# Access Compliance Report

### (Curb Ramps)

Intersection ID: 5574	Main Street: BANNER_ELK_DR	Cross Street: SUNSET_RD	Location: NE
ADA ID: 7343A25CD912	Ramp Type: BlendTrans1	Initial Pass/Fail: Fail	Overall Compliance: No
Severity Score: 8.75			
Codes/Mitigation Info/Possible Solution		Field Measurements/Component Compliance

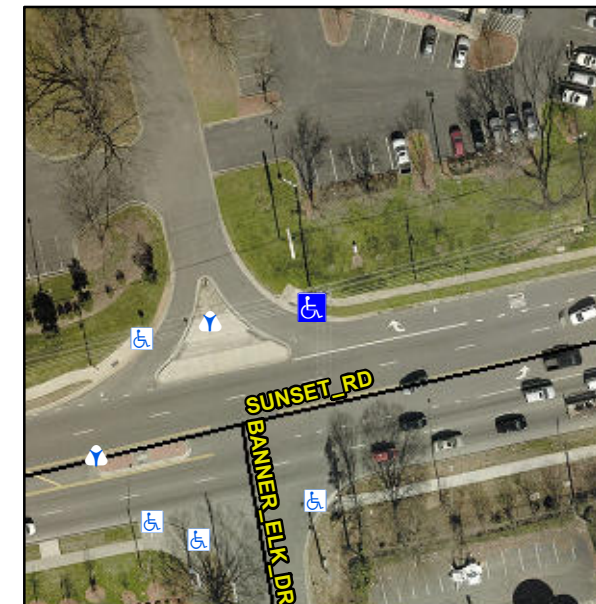
**Not Found, R304.5.1**

Compliance	Description	Data	Compliance	Description	Data
N/A	Ramp Length (in)	57.0	Yes	BlendTrans Slope (%)	2.6
No	Ramp Width (in)	47.0	Yes	BlendTrans XSlope (%)	0.9
N/A	Flare Type LT	N/A	N/A	Flare Type RT	N/A
N/A	Flare Slope LT (%)	N/A	N/A	Flare Slope RT (%)	N/A
N/A	Flare Traversable LT?	N/A	N/A	Flare Traversable RT?	N/A
N/A	Landing Length (in)	N/A	N/A	DWS Provided?	N/A
N/A	Landing Width (in)	N/A	N/A	DWS Contrast?	N/A
N/A	Landing Slope (%)	N/A	N/A	DWS Length (in)	N/A
N/A	Landing X Slope (%)	N/A	N/A	DWS Full Width?	N/A
N/A	Landing Curb? (Y/N)	N/A	N/A	DWS Offset (in)	N/A
N/A	Shared Landing?	N/A			
N/A	Gutter Ponding?	N/A	N/A	Gutter Slope (%)	N/A
N/A	Gutter Lip Ht (in)	N/A	N/A	Gutter X Slope (%)	N/A
N/A	Painted X Walk1?	No	N/A	Painted X Walk2?	N/A
	X Walk 1 Direction	To W		X Walk 2 Direction	N/A
	X Walk 1 Width (in)	N/A		X Walk 2 Width (in)	N/A
	X Walk 1 Slope (%)	1.9		X Walk 2 Slope (%)	N/A
	X Walk 1 X Slope (%)	4.1		X Walk 2 X Slope (%)	N/A

**Remove & Replace Curb Ramp With Two New Directional Ramps or Equivalent.**
